ADDENDUM NO. 2

**New Premium 63 Site Loop Campground
St. Francois State Park
Bonne Terre, Missouri
PROJECT NO.: X2317-01**

August 29, 2025

SHEET TITLE:
FLOOR PLAN
& ELEVATIONS

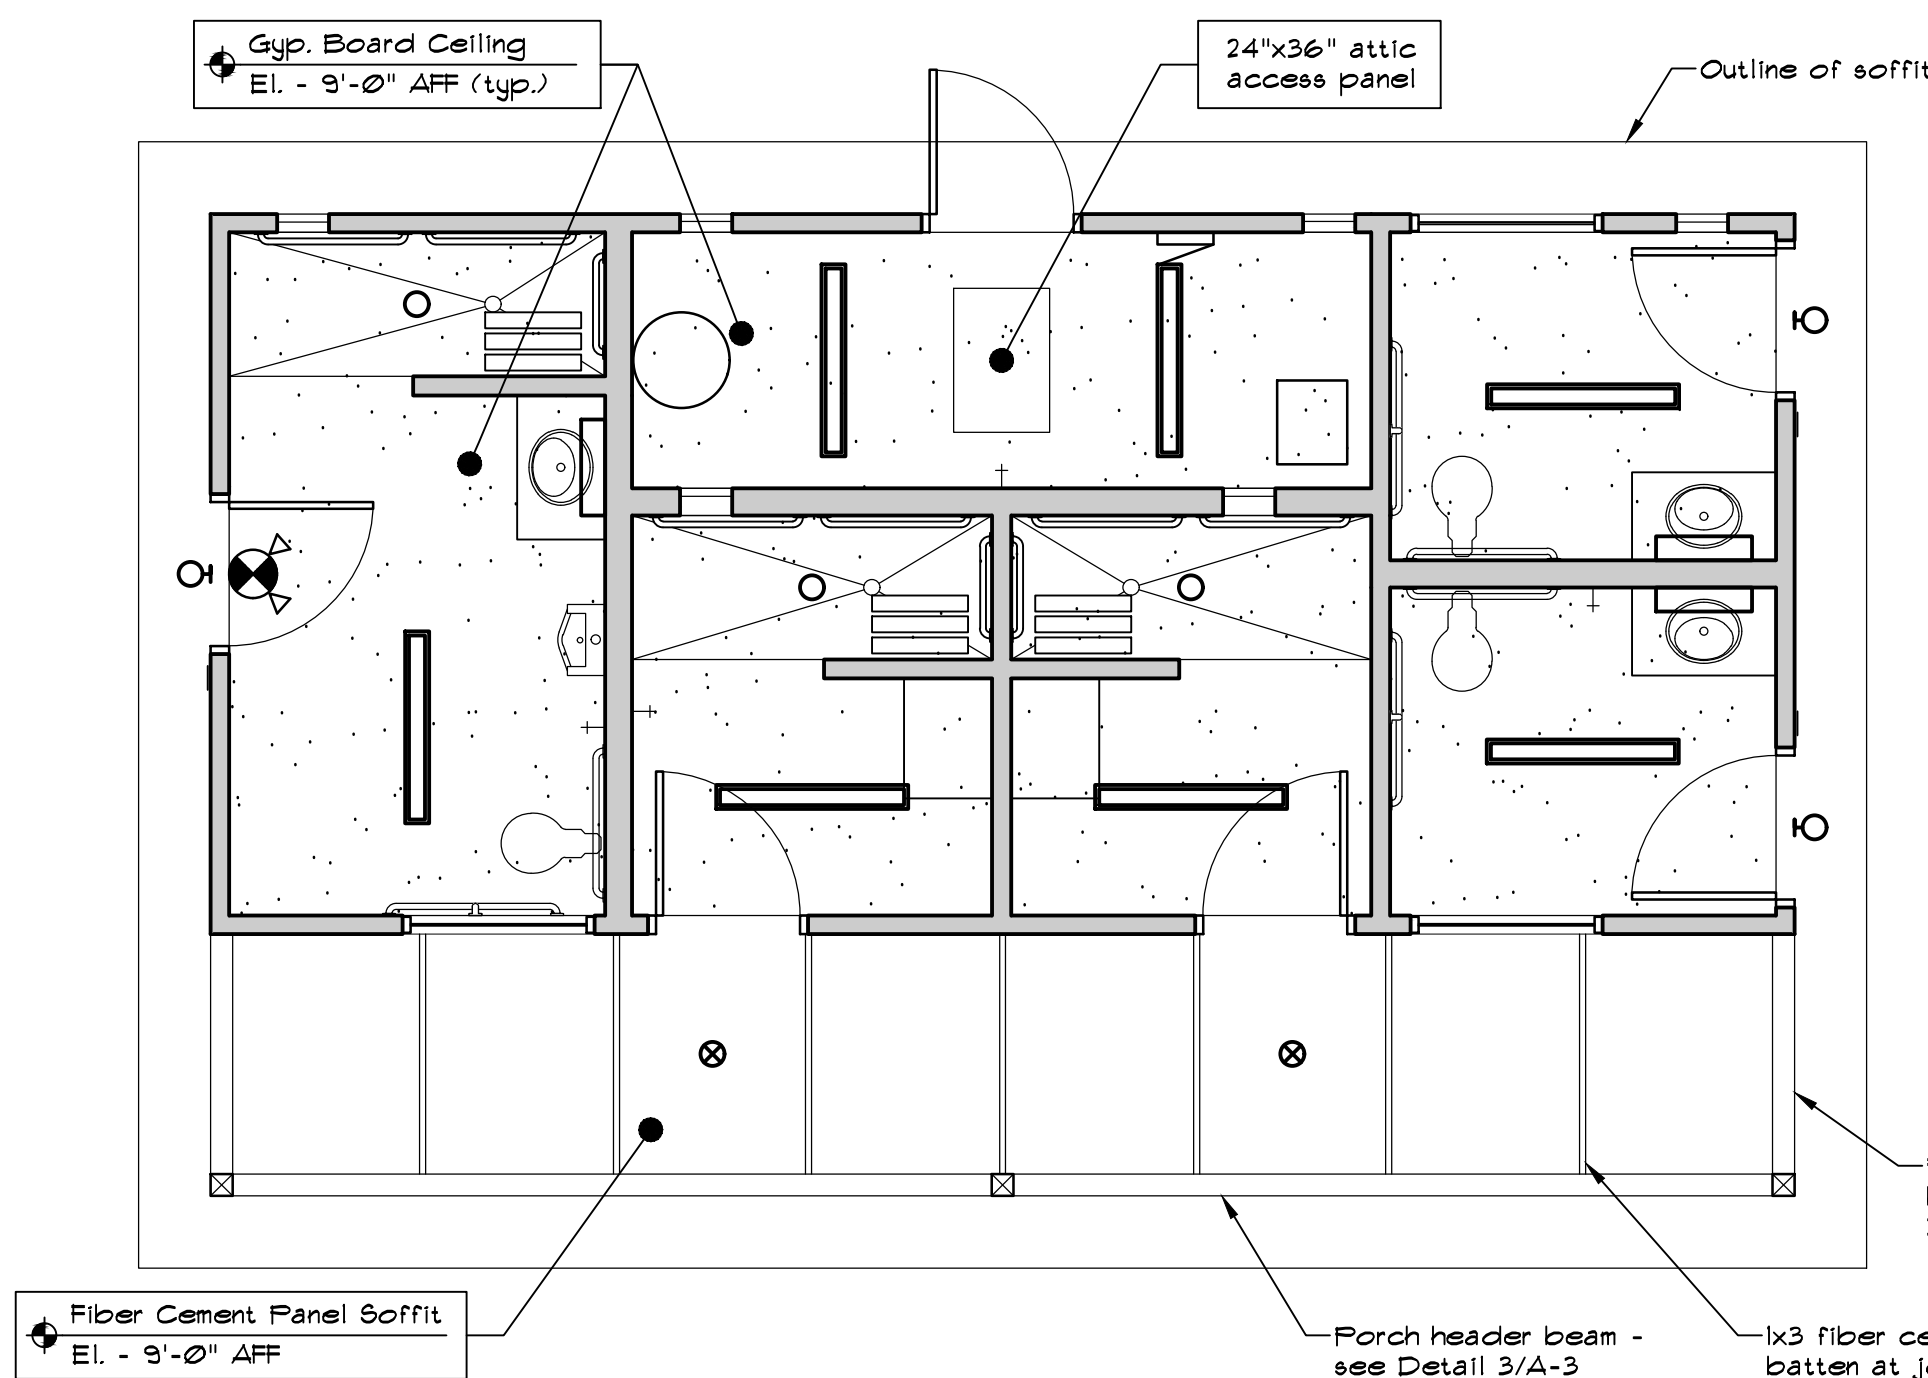
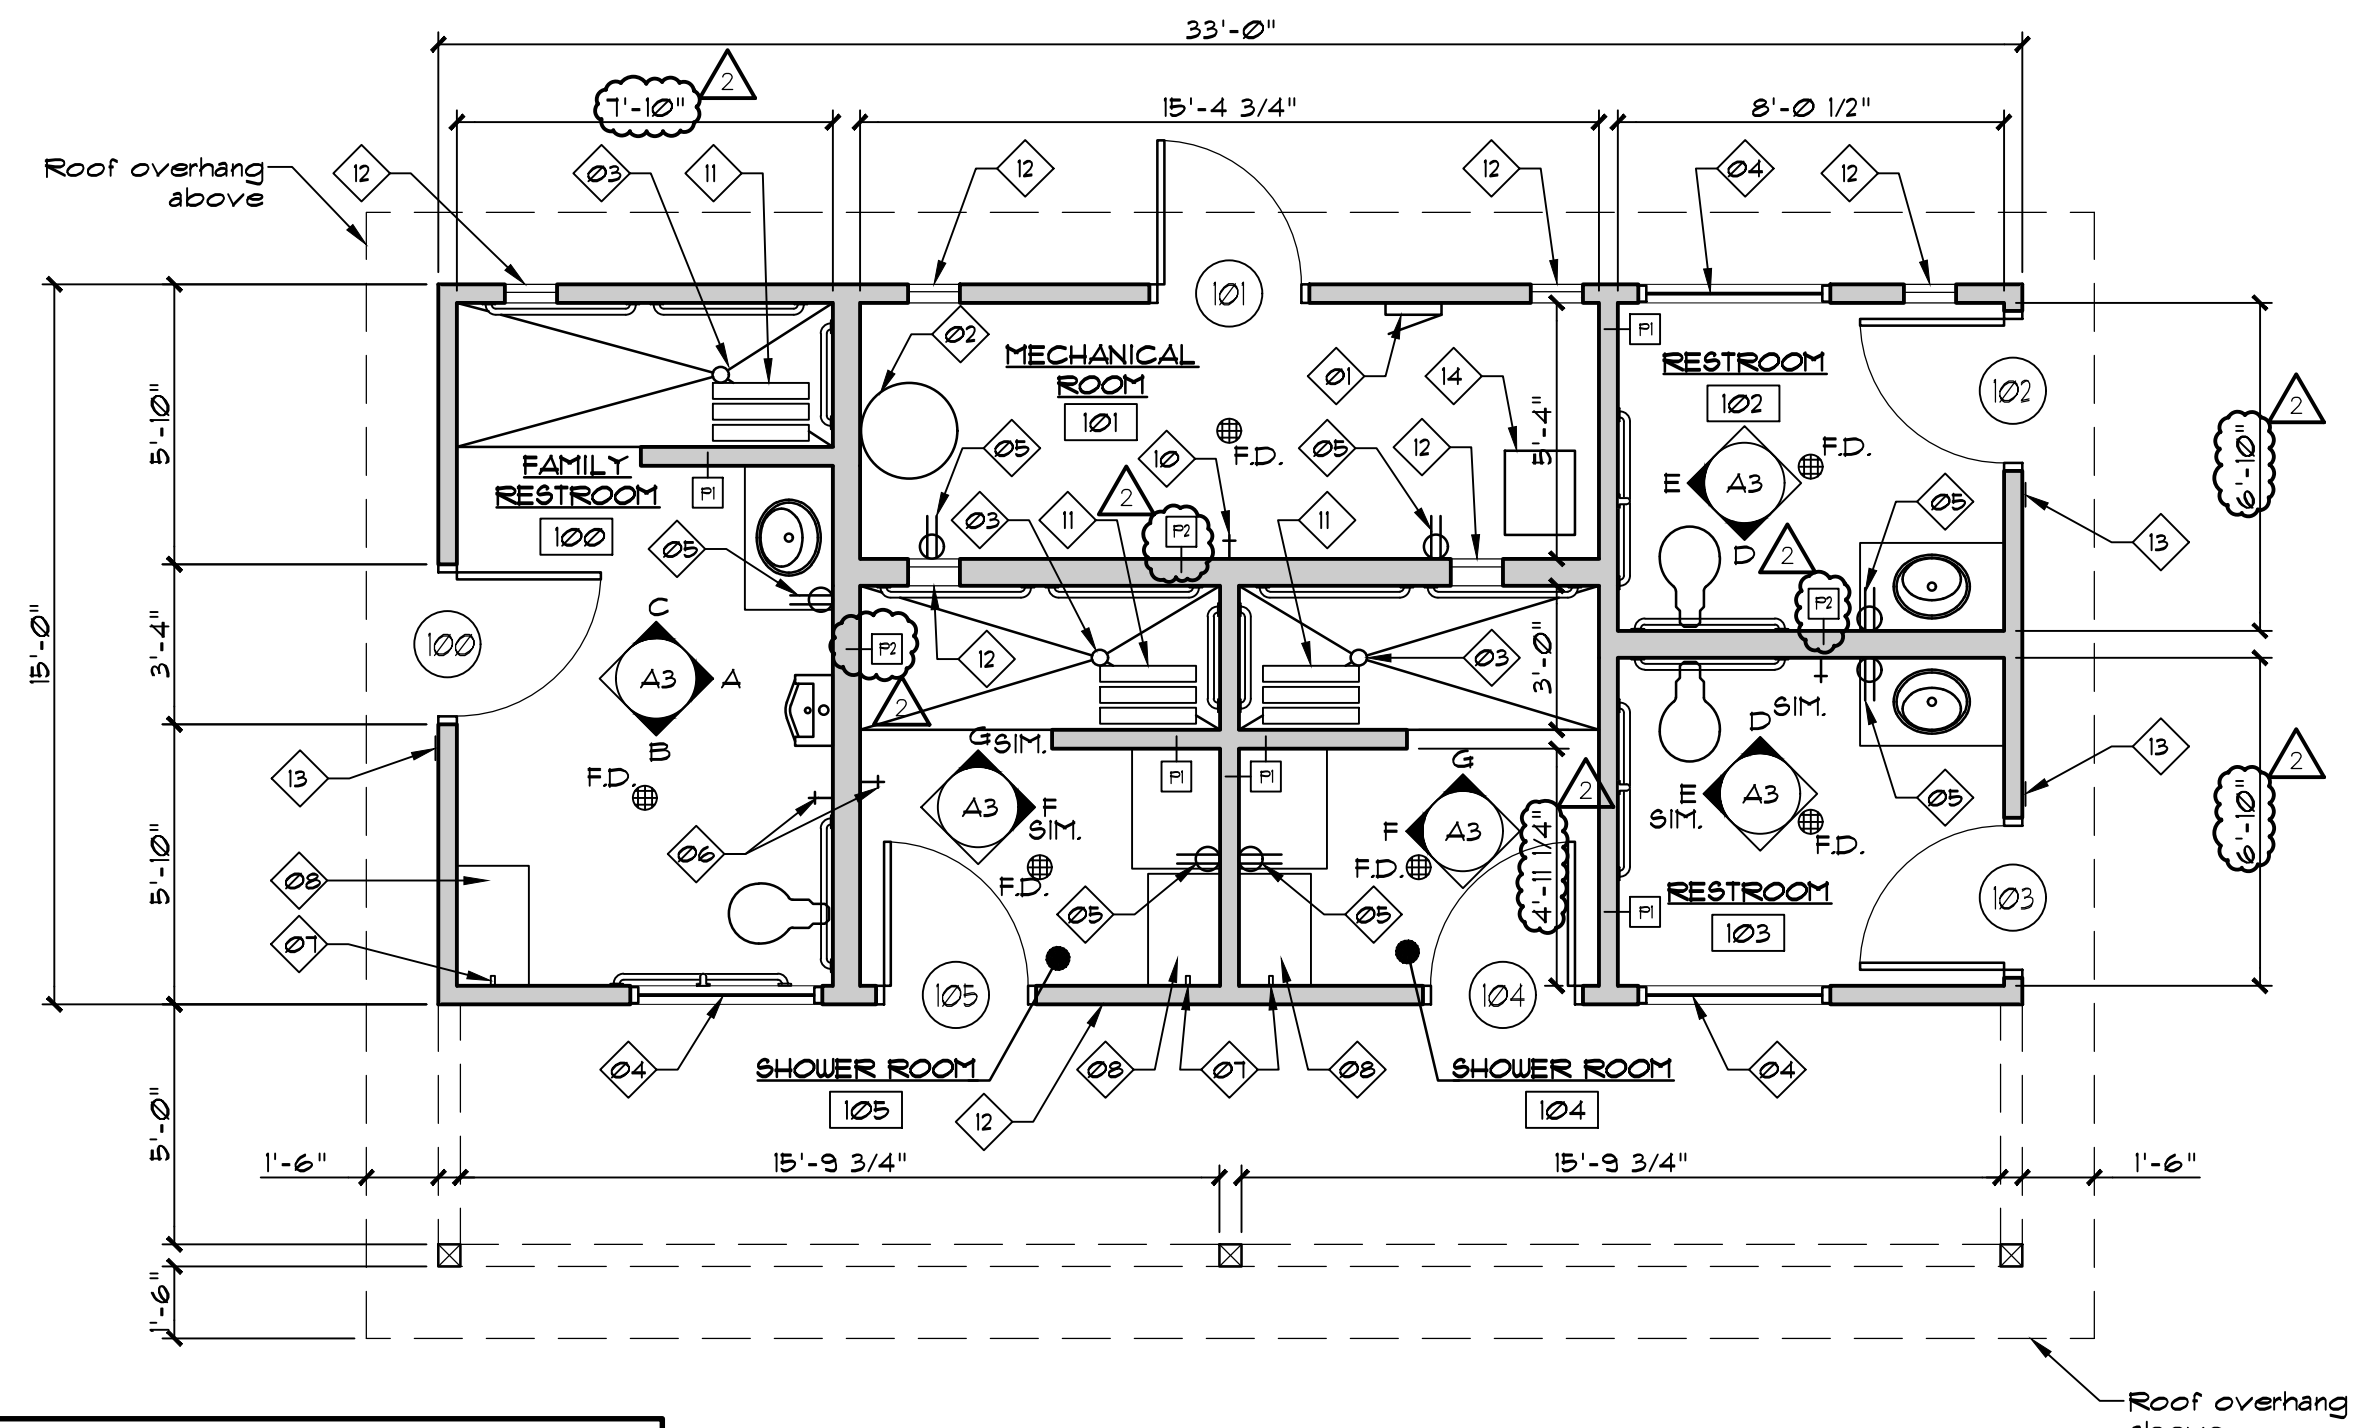
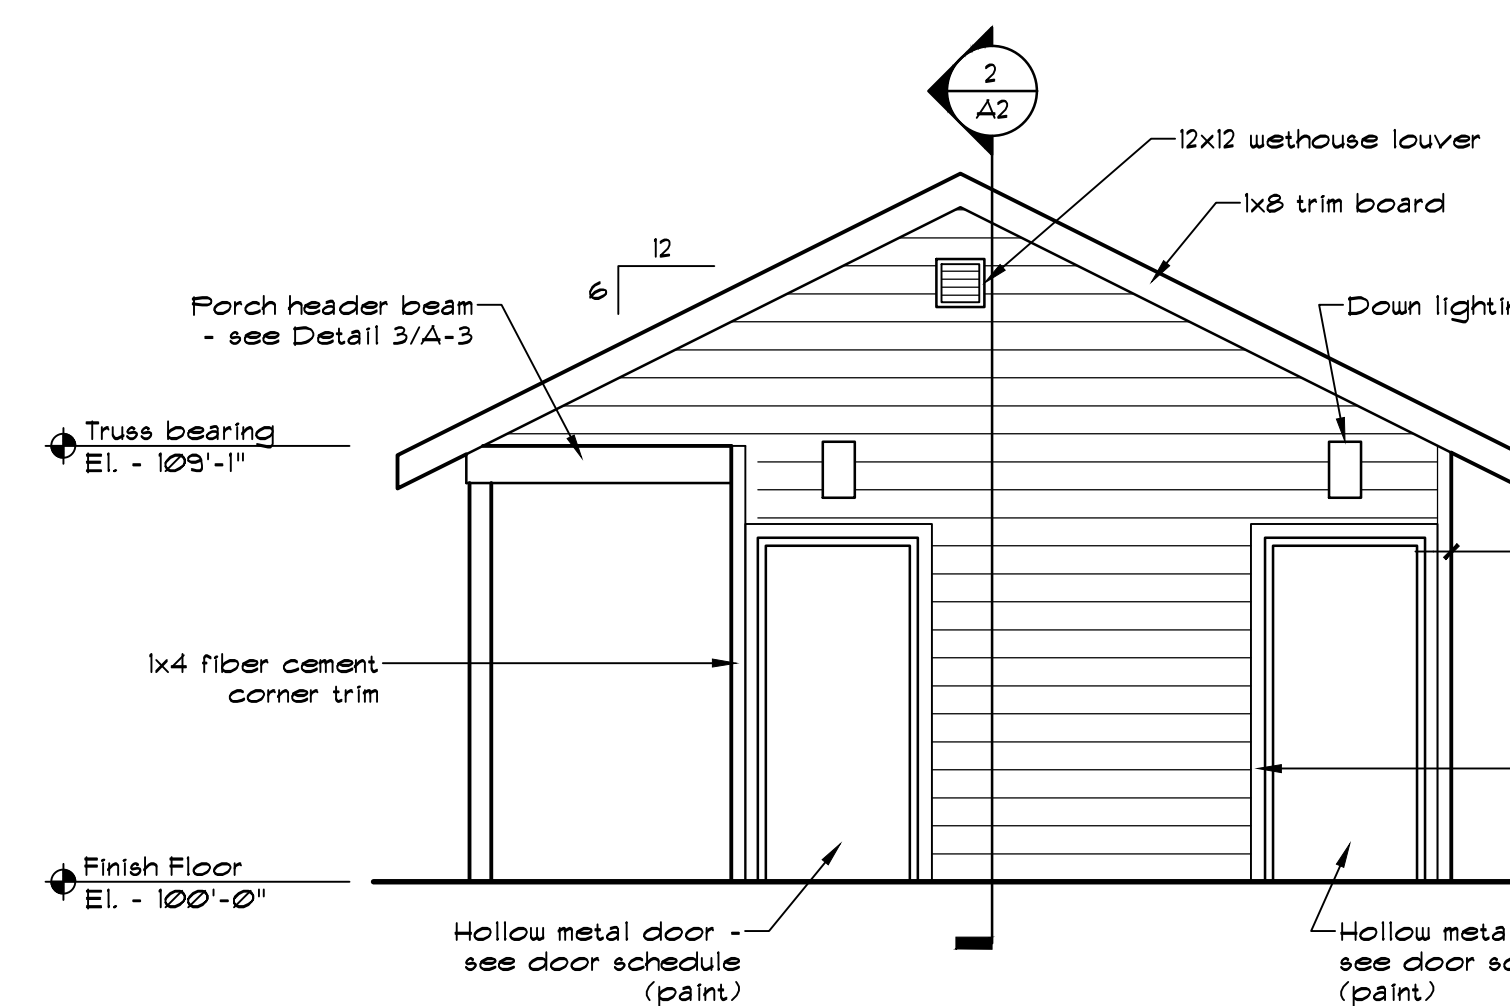
1. Modification: Changed wall thickness for plumbing walls.
2. Modification: Updated dimensions to match wall changes.
3. Modification: Updated partition type tags.
